**Re: *Addendum No. 1***  
***2026 Road Program***  
***Village of South Russell, Ohio***

Date: June 12, 2026

## DRIVE APRON REPAIR

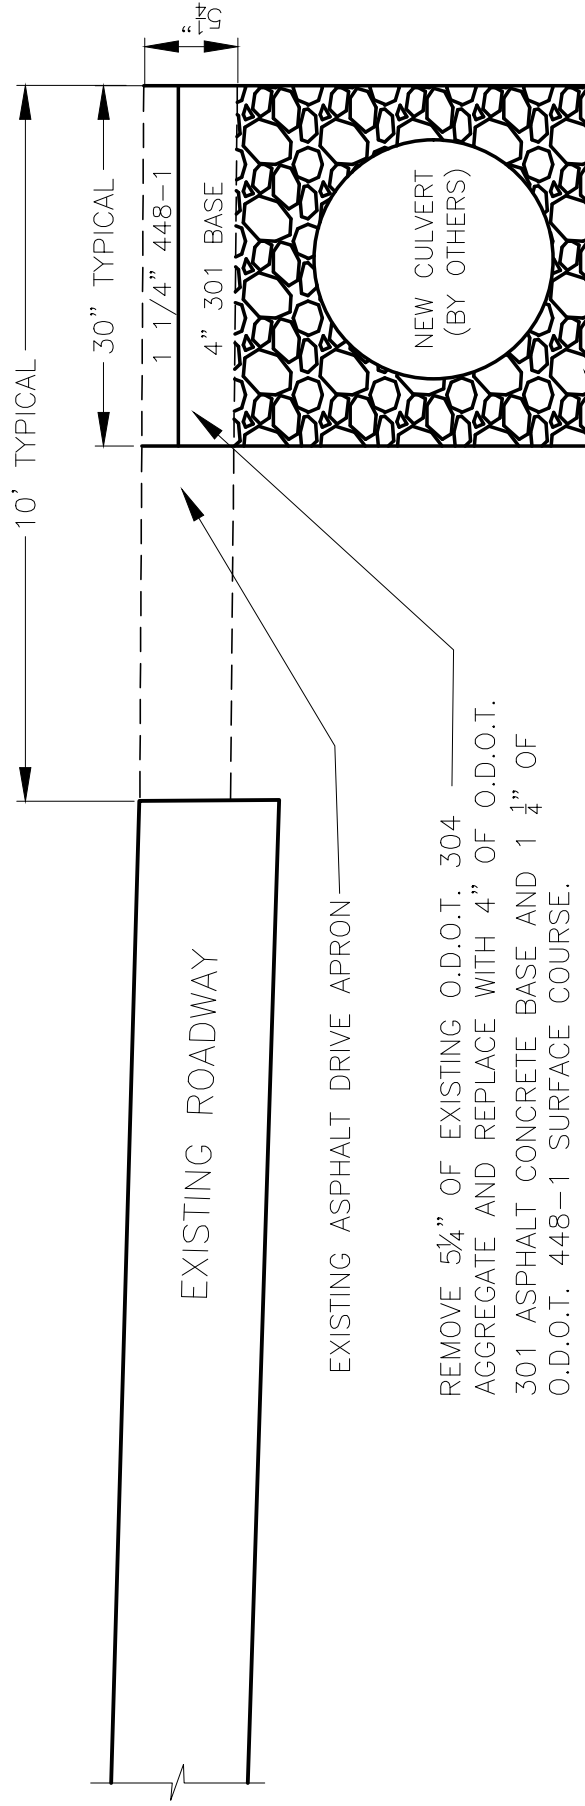
**Replace** the Drive Apron Repair Detail with the attached revised drawing.

The pay item shall be the measured SY of the total surface area of the repair and shall include all milling and saw cutting necessary for smooth transitions at the existing roadway and driveway pavements.

REMOVE 5/4" OF EXISTING O.D.O.T. 304  
AGGREGATE AND REPLACE WITH 4" OF O.D.O.T.  
301 ASPHALT CONCRETE BASE AND 1 1/4" OF  
O.D.O.T. 448-1 SURFACE COURSE.
